**Subject:** MHI's Responses to US-APWR DCD RAI No. 658-5130 Revision 2 (SRP 03.08.04)

**US-APWR Design Certification  
Mitsubishi Heavy Industries  
Docket No. 52-021**

**RAI NO.:** NO. 658-5130 REVISION 2  
**SRP SECTION:** 03.08.04 – Other Seismic Category I Structures  
**APPLICATION SECTION:** 3.8.4  
**DATE OF RAI ISSUE:** 11/15/10

POWER SOURCE BUILDING (WEST)  
 CONCRETE FLOOR  
 EL -26'-4"(B1F) & EL -14'-2"(BM1F)

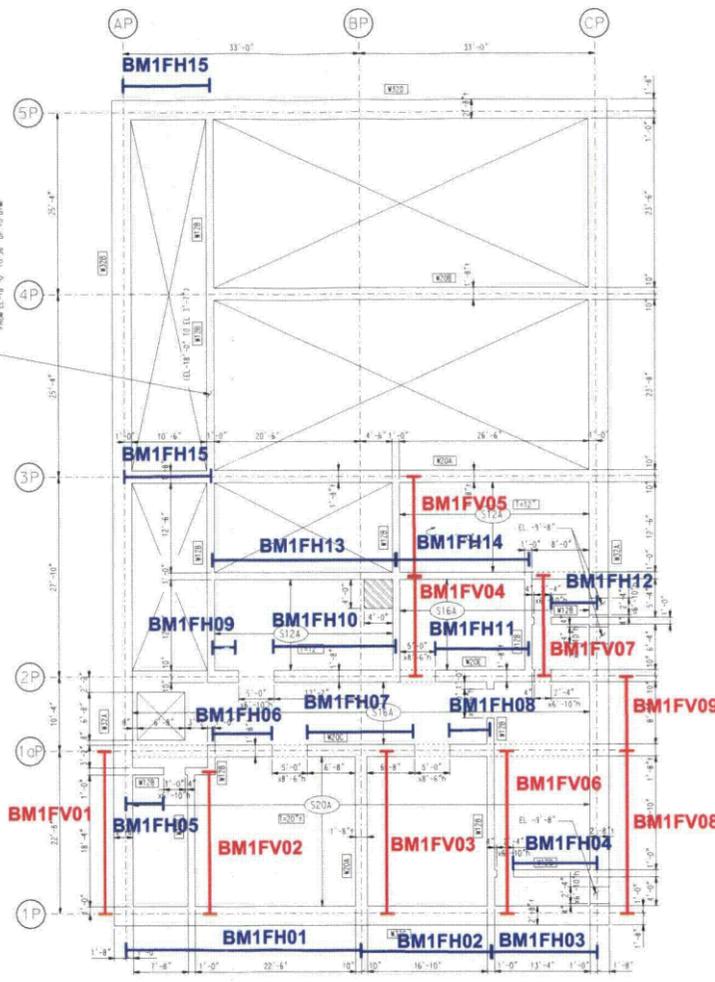
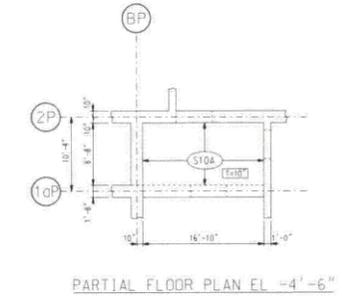
In the response to question 03.08.04-40, MHI states that boundary elements are not used because the aspect ratio of the wall is less than 2 as permitted by ACI 349-06 Section 21.7.6.1. The staff reviewed the ACI 349-06 Section 21.7.6.1 and concurs with the Applicant. However, MHI is requested to provide additional data to support their statement. Specifically, the Applicant is requested to provide a table that lists the aspect ratio,  $h_w/l_w$  defined in ACI 349-06 Section 21.7.6.1, for all of the shear walls.

The statement contained in this RAI question refers to the Power Source Building (PS/B) walls. The attached Table (Attachment 1 to this RAI) shows the ratio of the  $h_w/l_w$  for all the walls and wall segments of the West PS/B. The wall designation in the second column of this Table is shown on the attached URS drawings PSB-13-11-008-003 through 005 (Attachment 2 to this RAI). The  $h_w/l_w$  of all walls of West PS/B is less than 2 with a maximum  $h_w/l_w$  ratio of 1.72. The wall aspect ratios  $h_w/l_w$  of the East PS/B are less than 2 and similar to the West PS/B which had a maximum  $h_w/l_w$  ratio of 1.72.
